REGIONAL REVIEW FINDING

DATE: May 30, 2019 **ARC REVIEW CODE:** R1905142

Name of Proposal: Sugar Hill Distribution Center (DRI 2938)

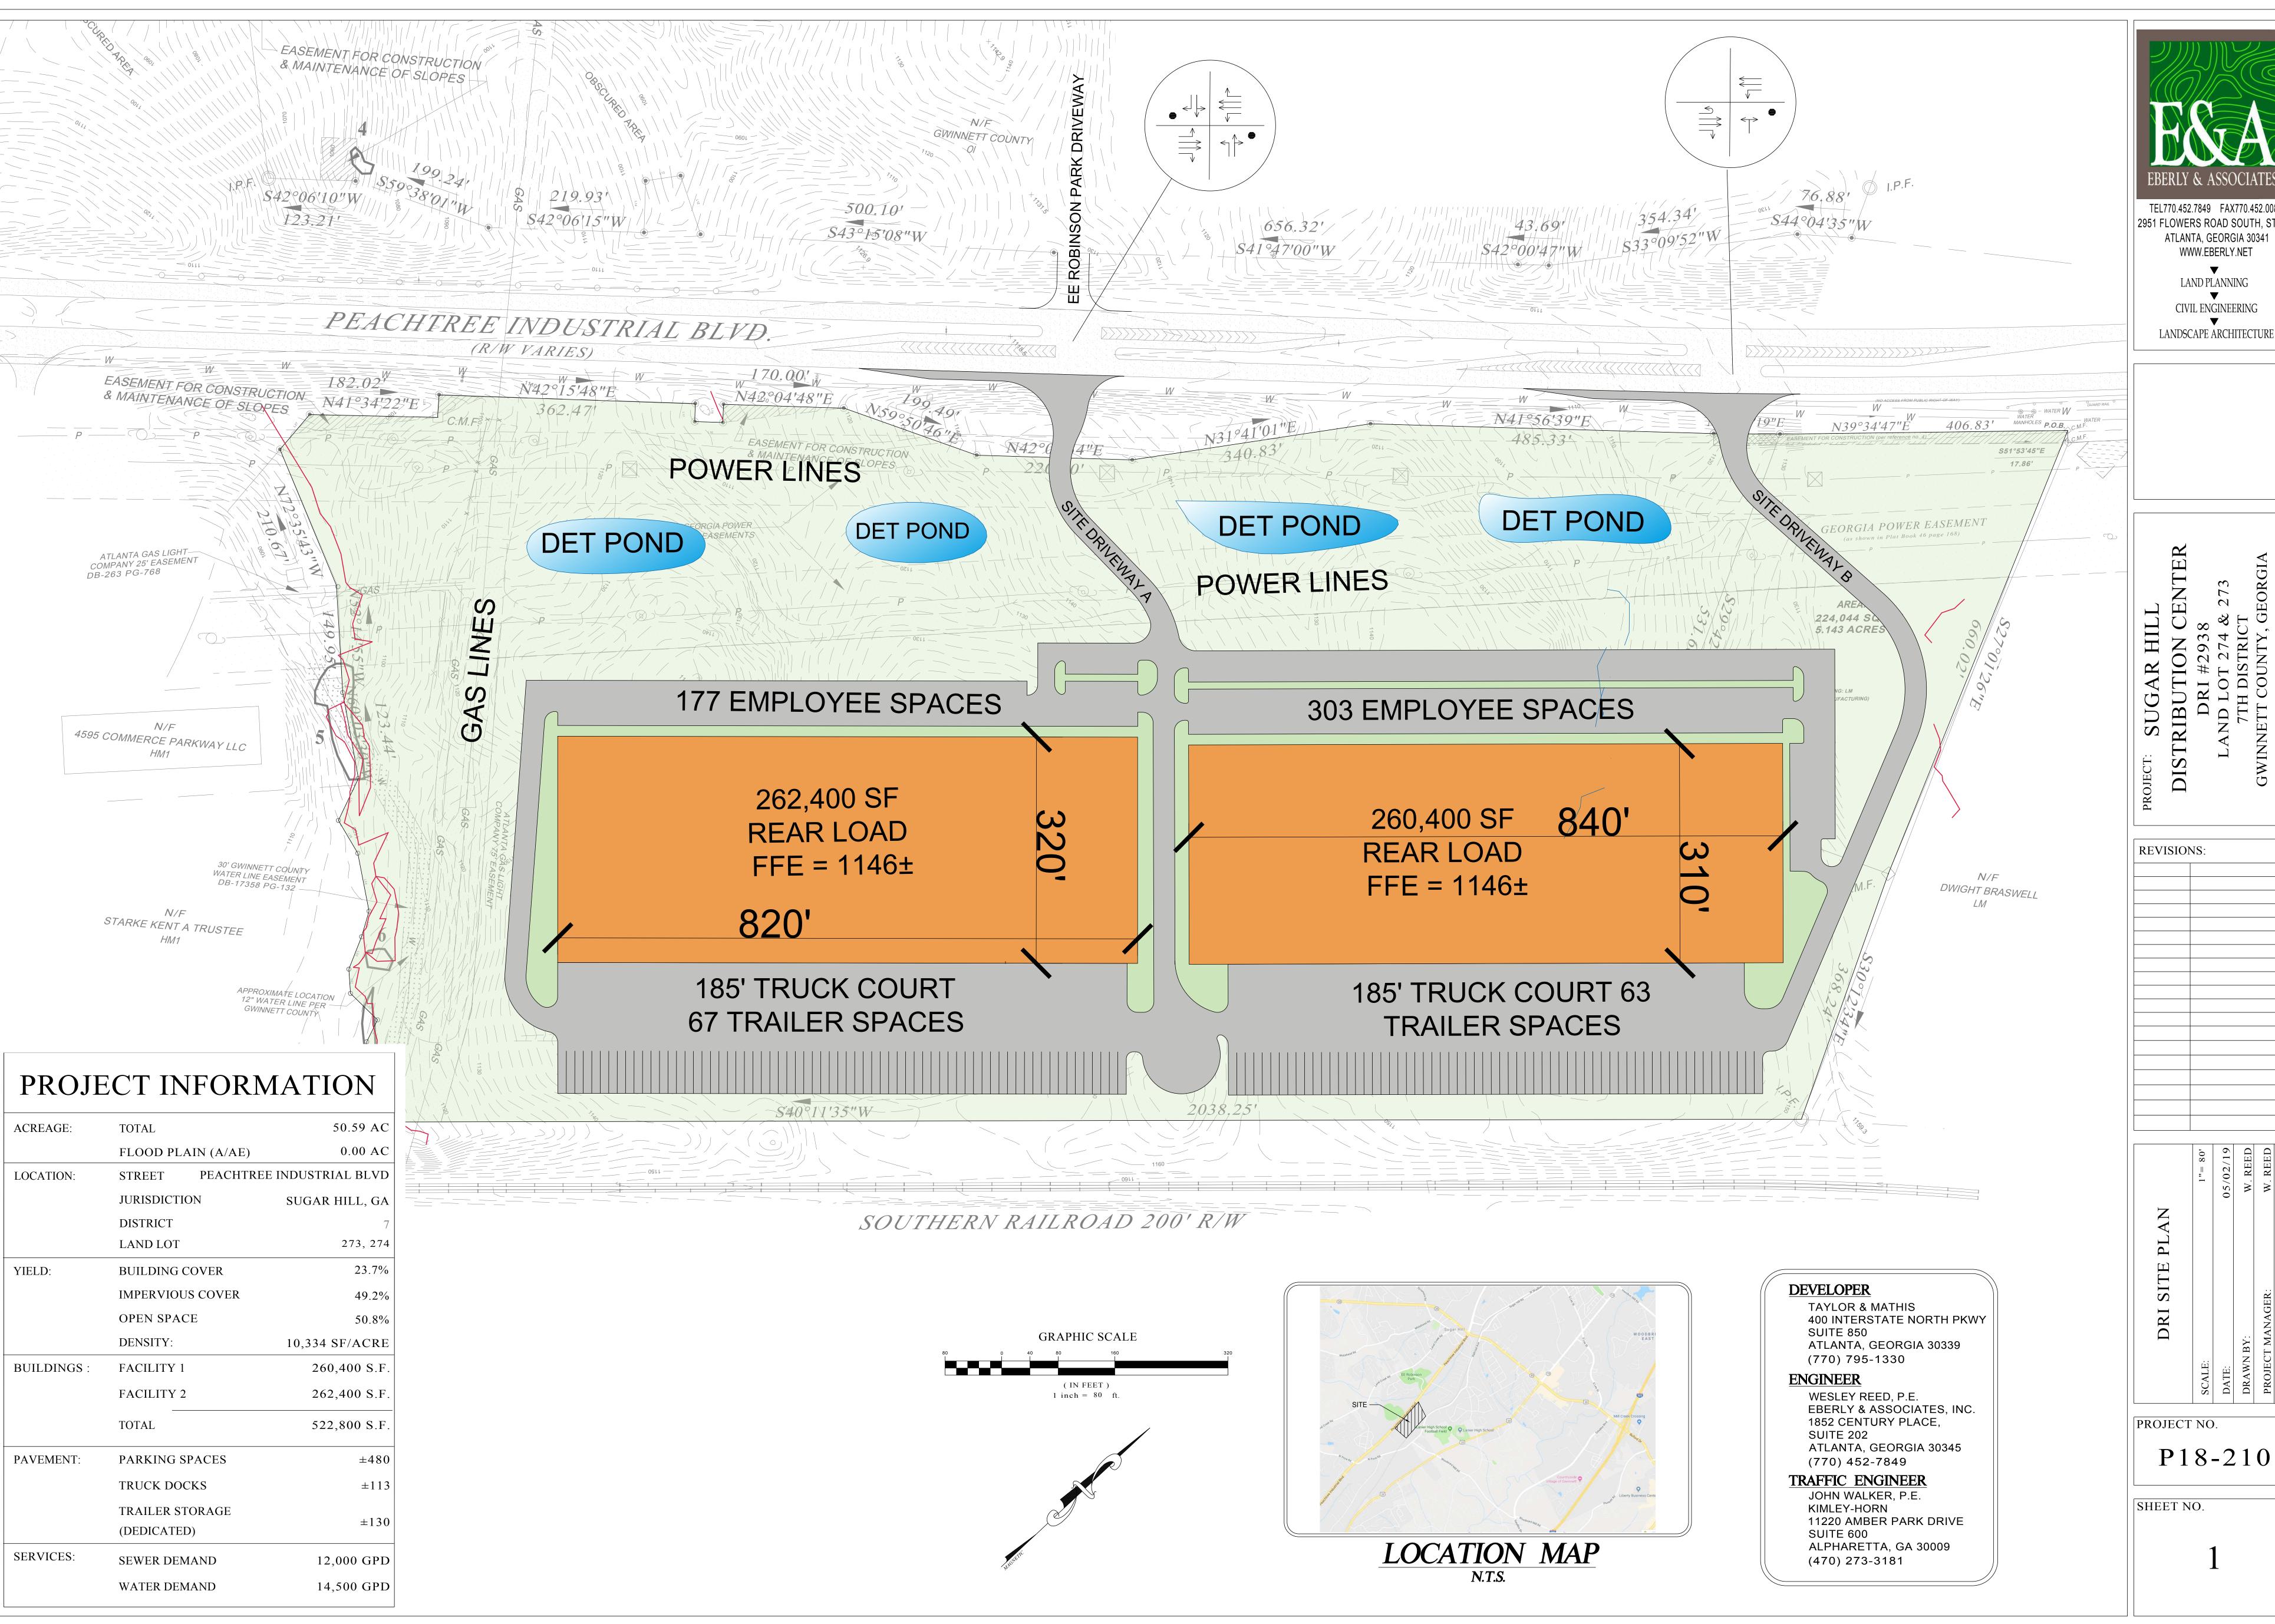
The USGS coverage for the project area shows no blue line streams on or adjacent to the property. The submitted site plan shows an unidentified broken blue line running through the northeastern proposed building and parking area to the northeasternmost detention pond. If this is an intermittent stream, it may be subject to the City of Sugar Hill's stream buffer ordinance and construction within any required buffers may require a variance. This also applies to any other unmapped streams on the property. All mapped or unmapped waters of the state on the property, including all streams, are also subject to the State 25-foot Sediment and Erosion Control buffer. Any development activity in the State 25-foot Erosion and Sedimentation buffer may require a variance. All required buffers on the property should be shown on the site plan.

09. Does the site plan provide for the construction of publicly accessible local road or drive aisle connections with adjacent parcels?
The ability for drivers and bus routes to move between developments without using the adjacent arterial or collector roadway networks can save time and reduce congestion. Such opportunities should be considered and proactively incorporated into development site plans whenever possible.
YES (connections to adjacent parcels are planned as part of the development)
YES (stub outs will make future connections possible when adjacent parcels redevelop)
NO (the site plan precludes future connections with adjacent parcels when they redevelop)
OTHER (Please explain)
The project proposes no stubouts or access to adjacent sites.
The project proposes no stubouts of access to adjacent sites.
